19.6-07

TECHNICAL BULLETIN

Squeaks & Rattles – Noise From Fascia – Movement of Steering Column Upper Bracket

MODEL 1995 MY
Sedan Range
VIN
720001-743506

ILLUSTRATION 1

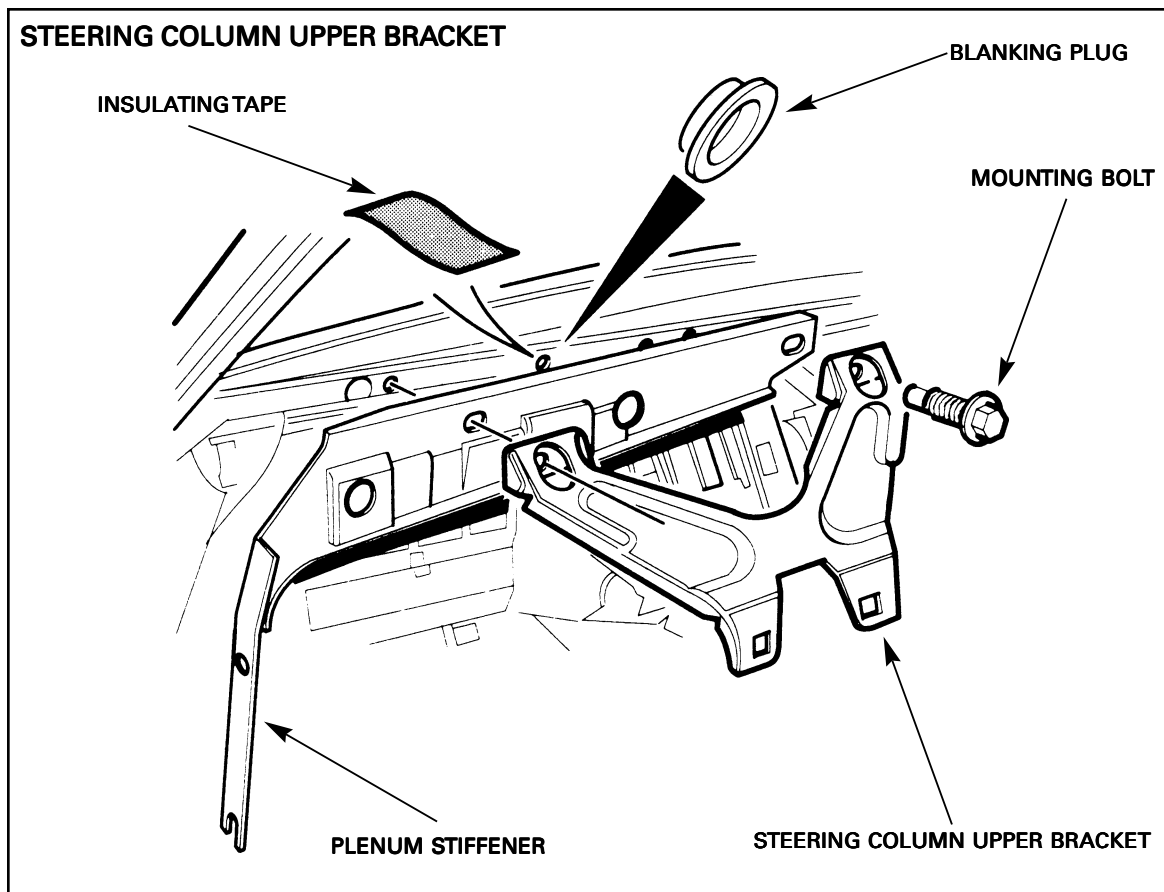
Some 1995 MY Sedan Range vehicles within the above VIN range may exhibit a noise that appears to come from the instrument area. The noise may be caused by movement of the steering column upper bracket against the plenum stiffener, Illustration 1, and the surface of the plenum.

The upper mounting bracket can move if it is not in full contact with the surface of the plenum. Blanking plugs or excess hardened sealer can prevent full contact thereby allowing movement.

11. Remove the retaining bolts and move the stiffener to obtain access to the plenum, Illustration 1.
12. Remove and discard the blanking plugs from the unused holes in the plenum (Illustration 1). Cover the holes with lengths of insulating tape to keep them air tight.

13. Clean any excess sealer from the surface of the plenum around the area of the mounting bolt weld nuts. This area should be flat without any projections.

14. If the paint surface around the holes has been damaged, paint the surface with a zinc-based paint.
15. Place the plenum stiffener, Illustration 1, into position against the A pillar and start the retaining bolts without final tightening.

16. Lift the steering column assembly from the temporary support and loosely attach the upper mounting bracket and the plenum stiffener to the plenum using new bolts. Do not final tighten the bolts.

17. Remove the support and align the plenum stiffener with the A pillar using the markings around the washers. Then, tighten the bolts securing the plenum stiffener to the A pillar.

18. Center the steering column with the instrument cluster and tighten the new bolts that secure the upper mounting bracket to the plenum to 17-23 Nm.
19. Clip the wiring harness connectors to the steering column bracket.
